**Merritt Boulevard Pavement Rehabilitation Project
Town of Trumbull, Connecticut**

RFP #5916 DUE: January 31, 2012 at 3:00PM

**Addendum No. 1
Issued January 24, 2012**

Mark	Date	Description
	01/20/12	ADDENDUM #1
PROJECT NO:	10196	
TITLE:	ES-QR-10196-01.dwg	
DRAWN BY:	AKM	AKM
CHECKED:	JWB	JWB
APPROVED:		
DETAILED ESTIMATE PLAN, NOTES, & DETAILS COMMERCE DR. & NUTMEG DR. SCALE: AS NOTED		
C1.1

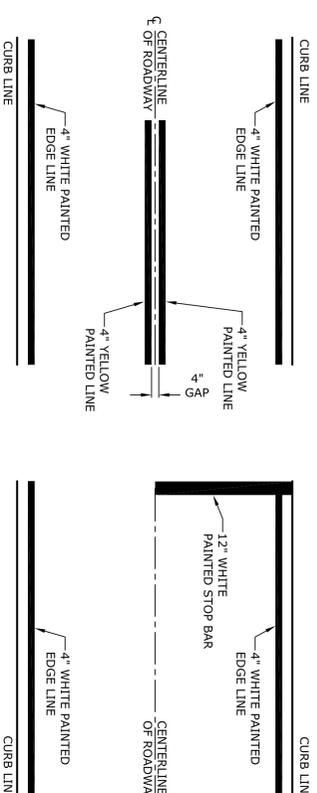
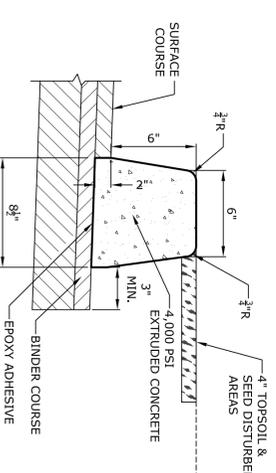
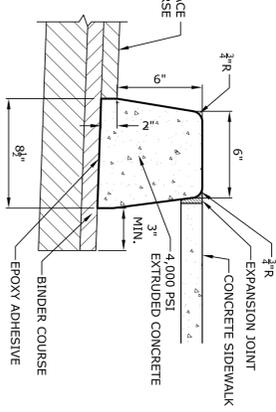
Item 1-4 Drawing C1.1, Detailed Estimate Plan, Notes and Details (Commerce Dr. & Nutmeg Dr.)

- 4. Will the extruded curb be a 6" placed on the top bituminous concrete pavement course or will the curb be placed on the bituminous concrete binder course?*

Remove the Pay Item "0969070A – Construction Field Office, Furnishings and Equipment"

Per the details for Extruded Concrete Curb on C1.0 & C1.1, the curb will be installed on the bituminous concrete binder course and will have a 6" reveal above the bituminous concrete surface course (total curb height of 8").
